3GPP TSG SA WG3 Security — S3#18 **S3-010182**

CHANGE REQUEST

Title:	⌘	Correction to COUNT-C description
Source:	⌘	Siemens Atea
Work item code:	⌘	Security ***Date:*** ⌘ 17/05/2001
Category:	⌘	**A** ***Release:*** ⌘ Rel-4

Figure 16c: The structure of COUNT-C for all transmission modes

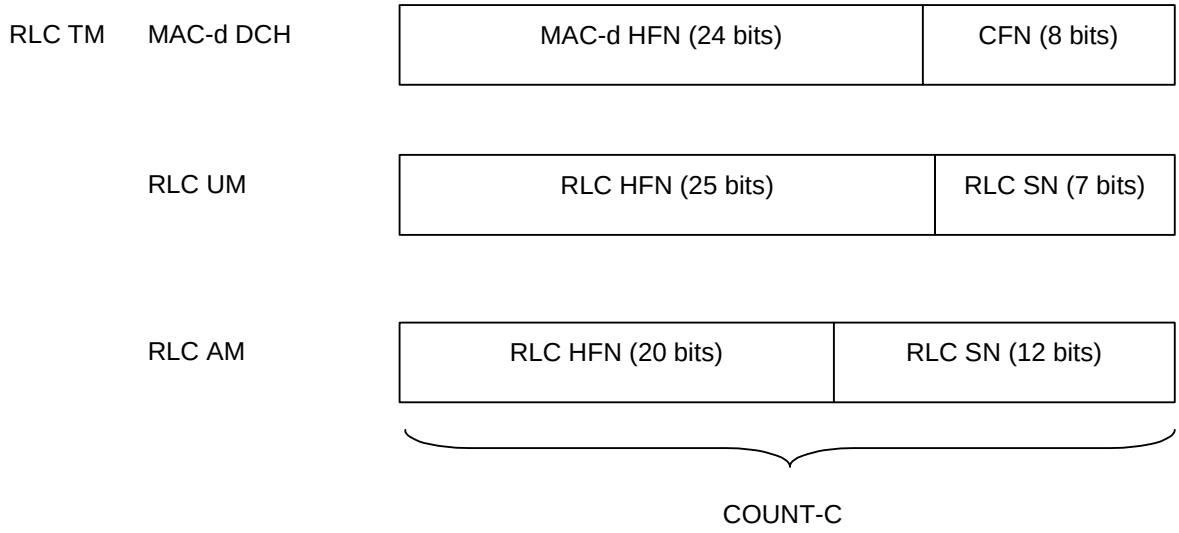
There is one COUNT-C value per up-link radio bearer and one COUNT-C value per down-link radio bearer using RLC AM or RLC UM. For all transparent mode RLC radio bearers of the same CN domain COUNT-C is the same, and COUNT-C is also the same for uplink and downlink. ~~There is one up-link COUNT-C value and one down-link COUNT-C value for all radio bearers using the transparent RLC mode that are connected to the same CN domain (and mapped onto DCH).~~

COUNT-C is composed of two parts: a "short" sequence number and a "long" sequence number. The "short" sequence number forms the least significant bits of COUNT-C while the "long" sequence number forms the most significant bits of COUNT-C. The update of COUNT-C depends on the transmission mode as described below (see figure 16c).

- For RLC TM on DCH, the "short" sequence number is the 8-bit connection frame number CFN of COUNT-C. It is independently maintained in the ME MAC-d entity and the SRNC MAC-d entity. The "long" sequence number is the 24-bit MAC-d HFN, which is incremented at each CFN cycle.
- For RLC UM mode, the "short" sequence number is the 7-bit RLC sequence number (RLC SN) and this is part of the RLC UM PDU header. The "long" sequence number is the 25-bit RLC UM HFN which is incremented at each RLC SN cycle.
- For RLC AM mode, the "short" sequence number is the 12-bit RLC sequence number (RLC SN) and this is part of the RLC AM PDU header. The "long" sequence number is the 20-bit RLC AM HFN which is incremented at each RLC SN cycle.
